**Genesis Solar Energy Project - Docket Number 09-AFC-8**

Included with this letter is one hard copy and one electronic copy of the **Genesis Solar Energy Project Application for Certification Data Request Responses to Set 1B.**

Responses to Data Requests #228 through #292 were compiled in response to the Energy Commission's Genesis Solar Energy Project (09-AFC-8) Data Requests, Set 1b, dated December 9, 2009 and posted December 10, 2009. This document provides the additional information necessary to fulfill the Application for Certification data requests for the following technical areas:

DR 276 (Figure3-a) Genesis Solar Energy Project  
 Project Area Current Proposed Right-of-Way  
 and Surveyed Area

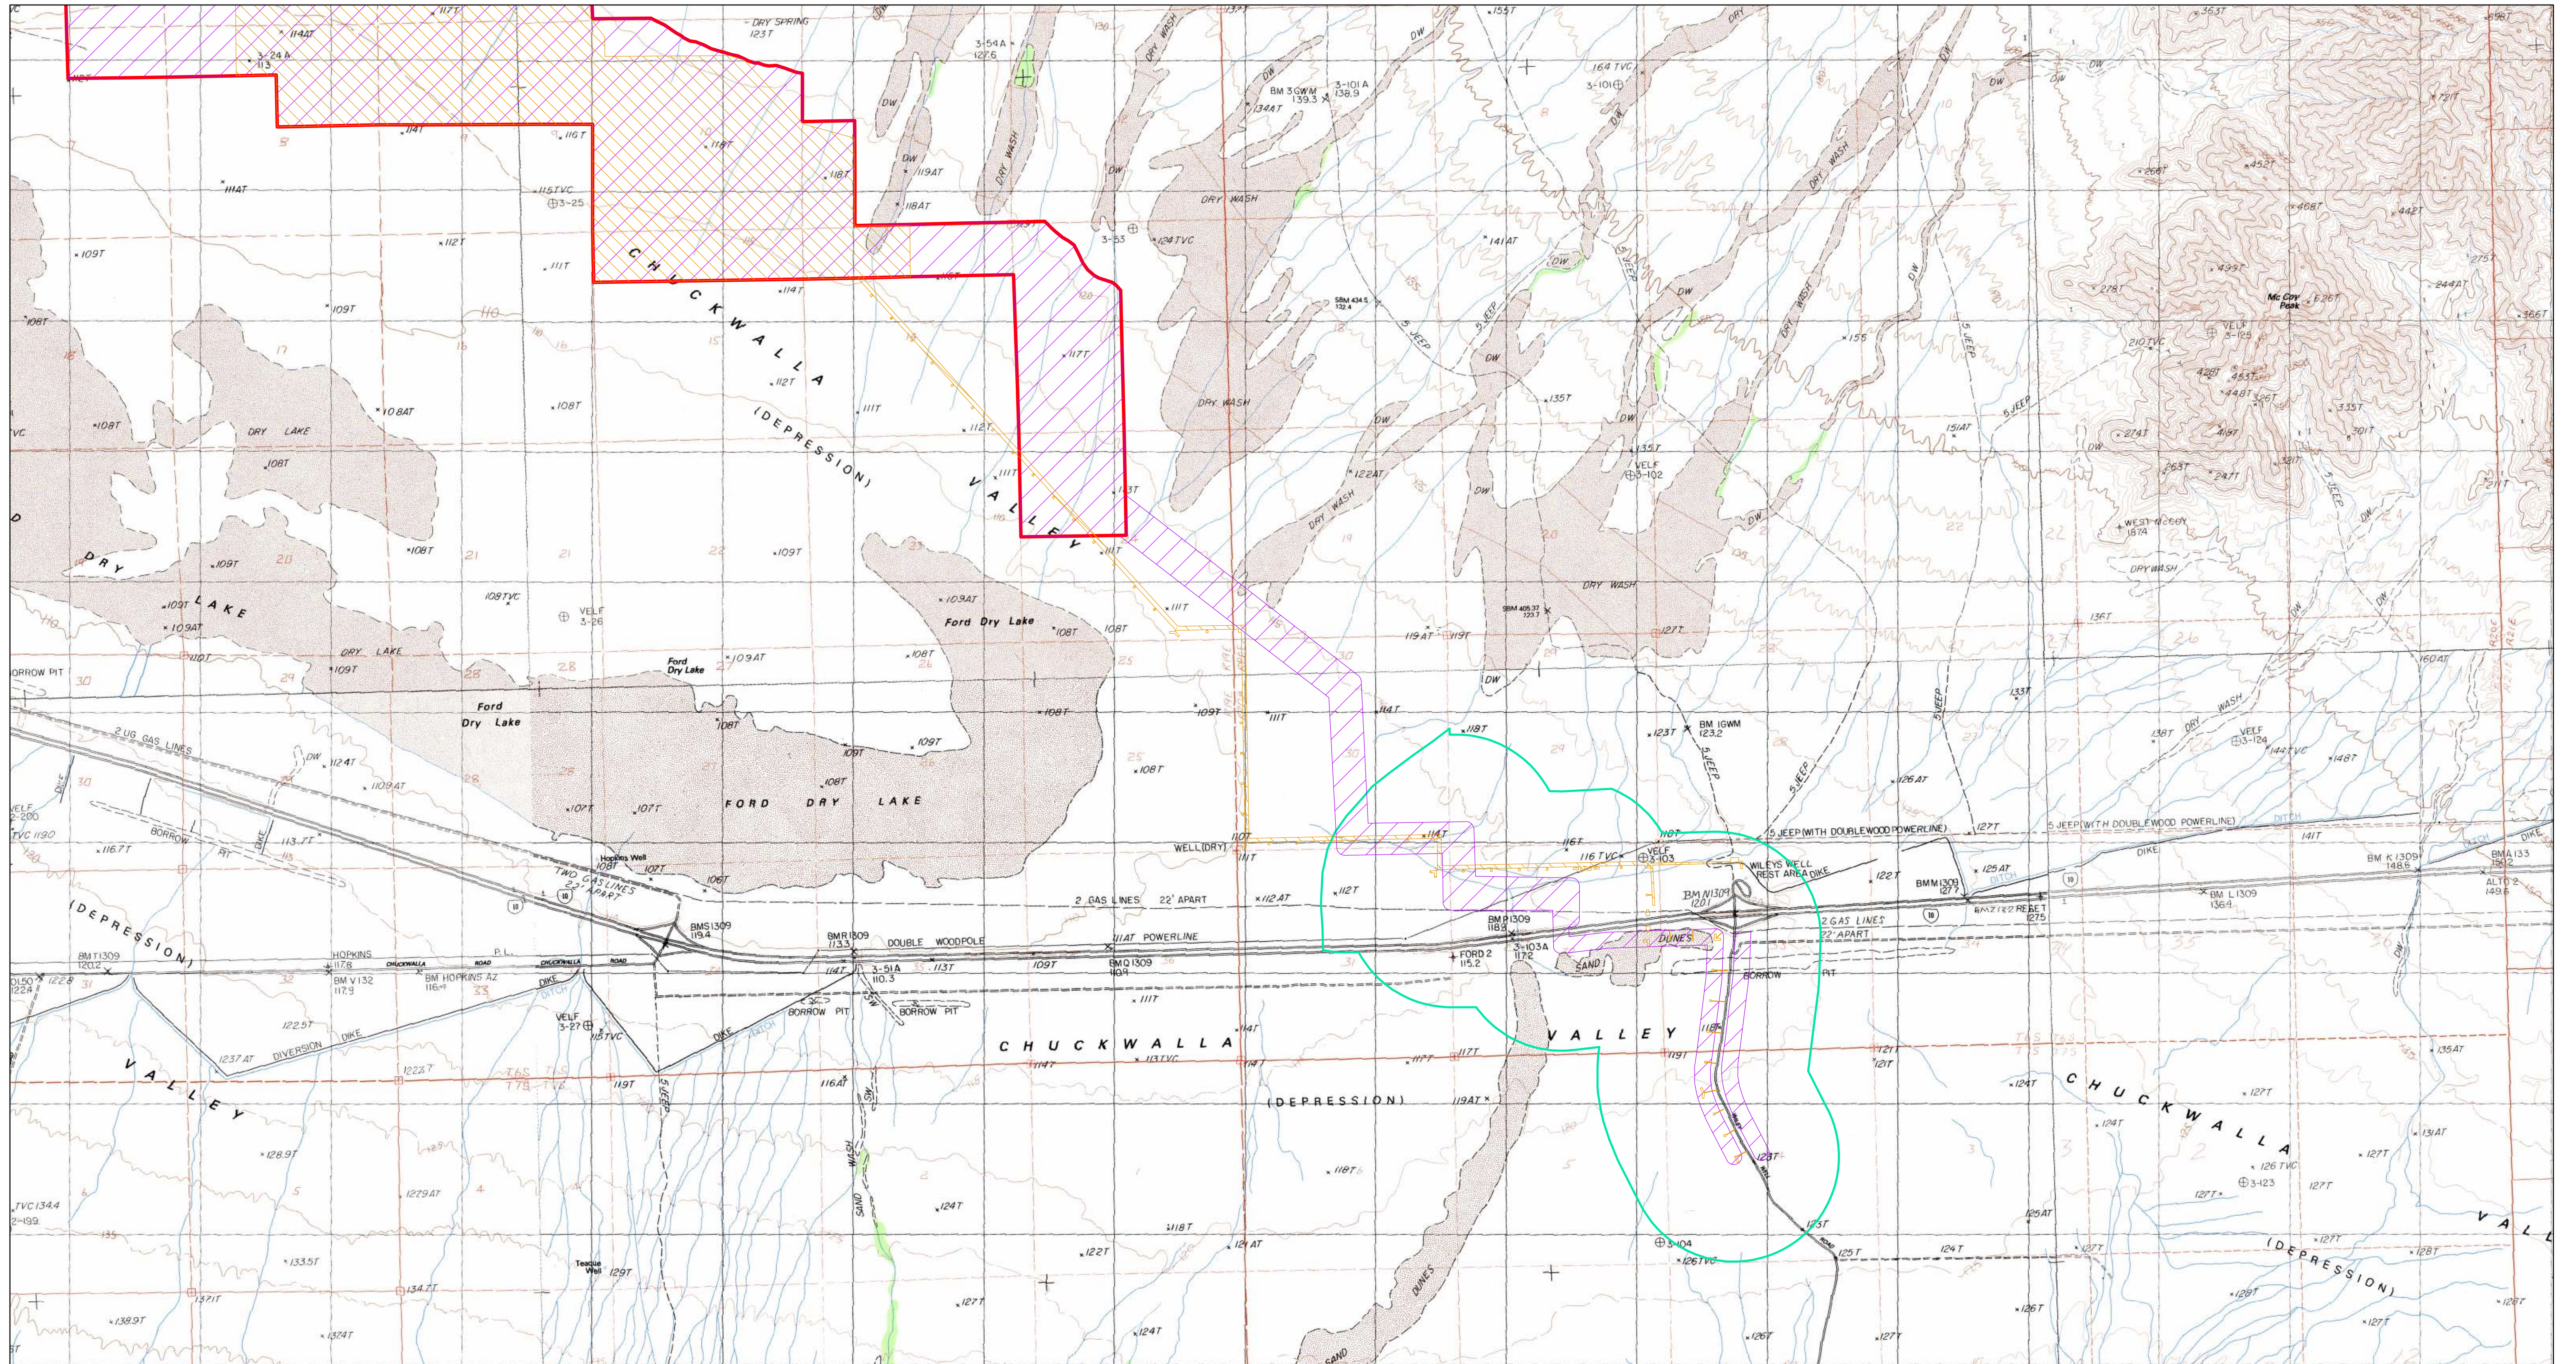
Please provide revised Figures 3-a and 3-b showing the APE as cross-hatched areas, with the cross-hatching appropriately labeled in the legends of both figures.

Please see attached Figure DR276 (3a) and DR276 (3b).

**Figure DR-292**

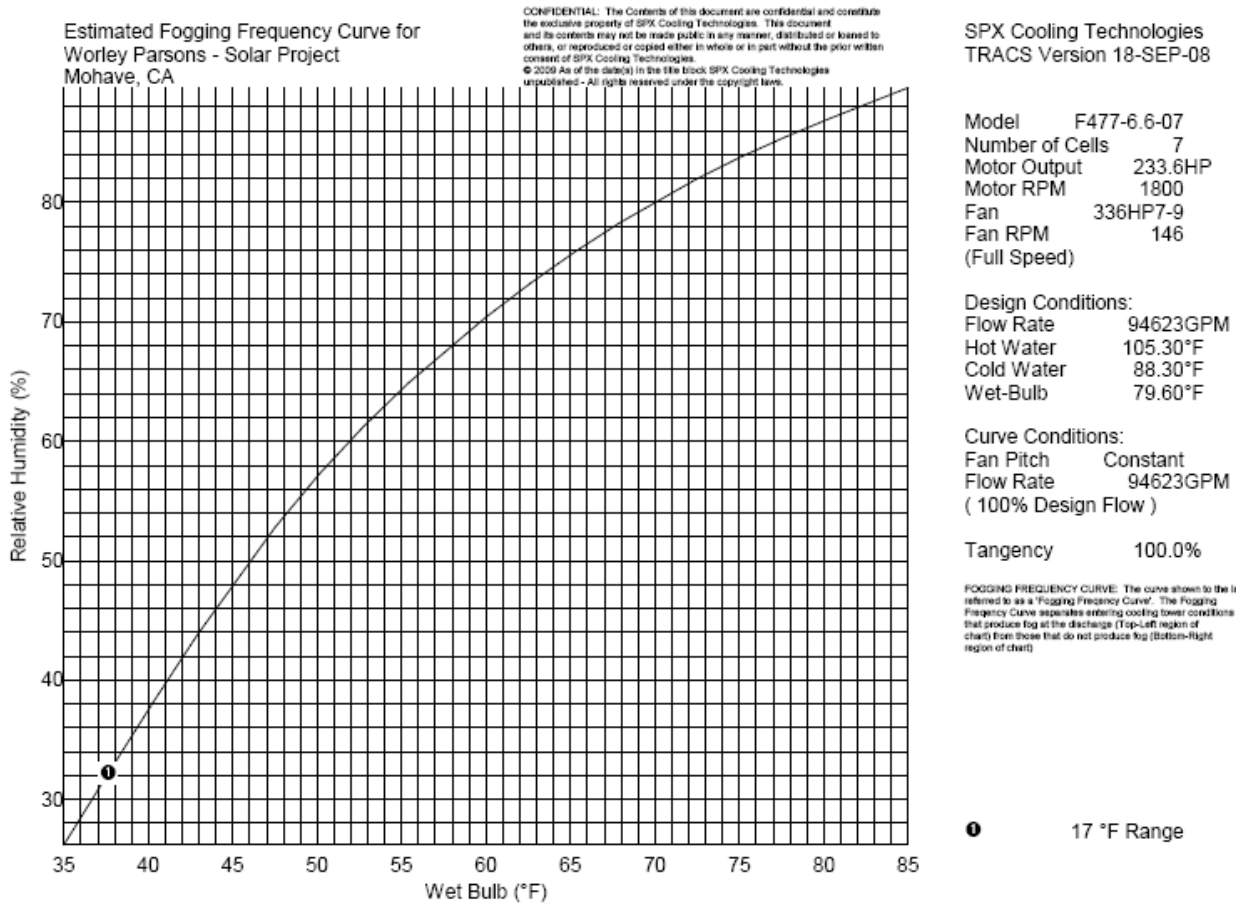
Please provide the cooling tower manufacturer and model number information and a fogging frequency curve from the cooling tower vendor for the two cooling towers, if available.

The anticipated manufacturer and model number for both cooling towers are SPX Cooling Technologies, Model No. F477-6.6-7. A fogging frequency curve for the proposed cooling tower was provided in Appendix B.1 of the AFC, but has been included in this response as Figure DR-292.
